寄件者: [REDACTED]
寄件日期: 2026年09月29日星期二 15:55
收件者:
主旨: Fwd: Planning Application No. A/NE-TK/872 - Departmental Comments
附件: 2026-09-28 車流量表格.pdf; 2026-09-28 route to bus stop.pdf; 20260921 Fire Proposal.pdf; 2026-09-29 site plan (caravan and canopies added).pdf

Dear Sir/Madam,

In regard to the Planning Department's comments, please find the response below:

Planning Application Proposed temporary Holiday Camp with Ancillary Facilities for a period of 3 years	Site Plan (with dimensions)	Site Location D.D.17 Lot No(s).468(part),477,478
---	---	---

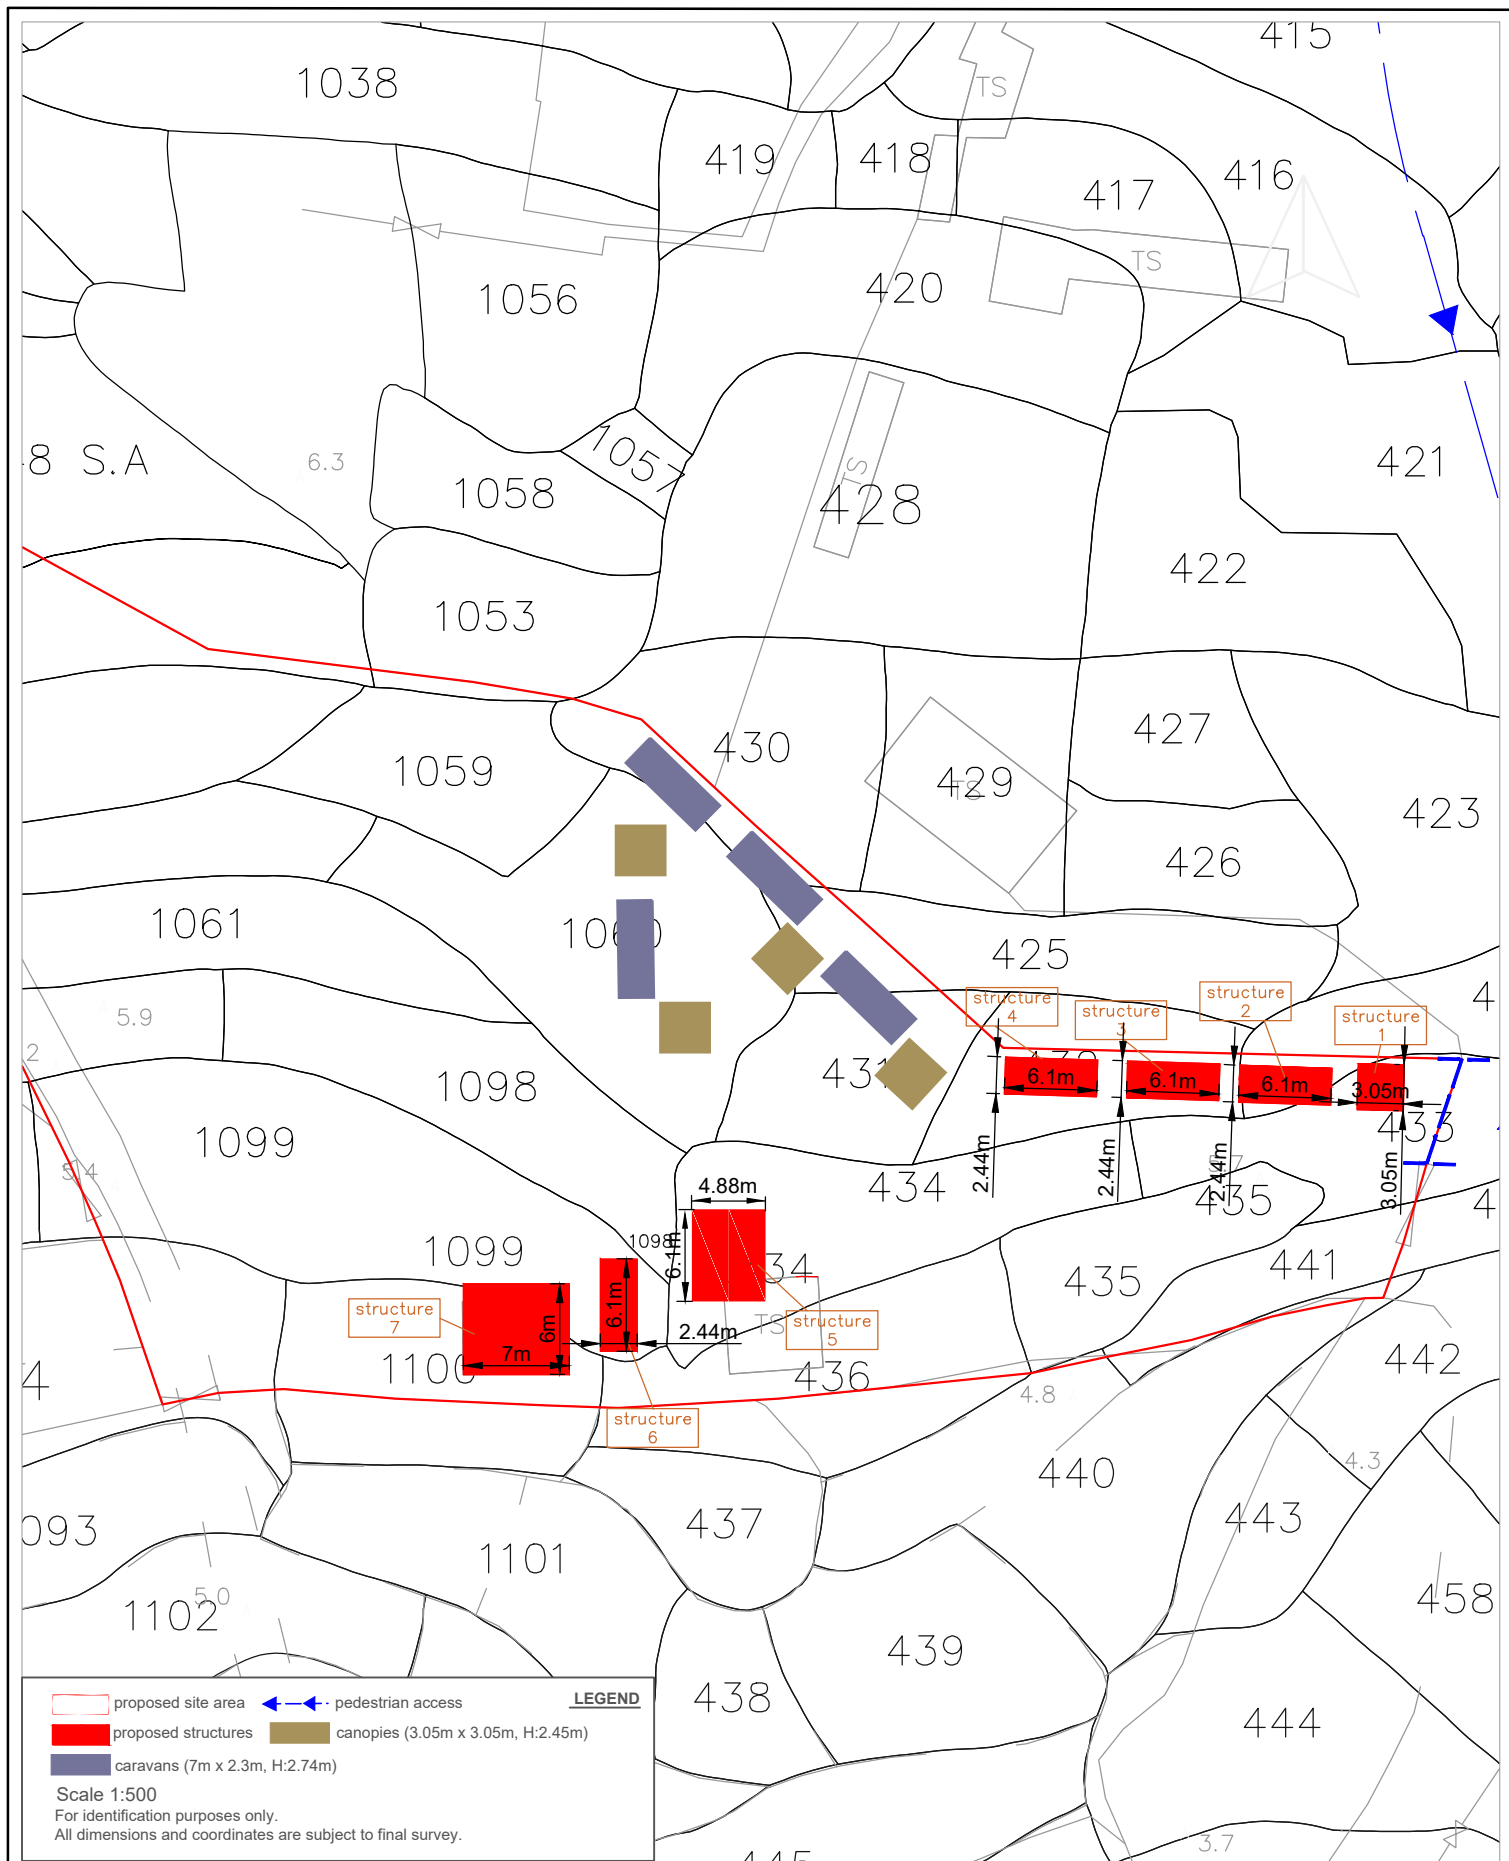
1. The said caravans and canopies are intended to be used for the application, there are 4 caravans on site (size: 7m x2.3m, height 2.74m) totaling approximately 64.4m² and 4 canopies (size: 3.05m x3.05m, height 2.45m) totaling approximately 37.2m². A site plan is attached for your review.

However, the caravans function as activity booths/station vehicles rather than on-site fixed structures and the canopies are only non-permanent sunshades erected temporarily during operational hours. Being movable, non-permanent and involving no building works, they do not constitute 'structures'.
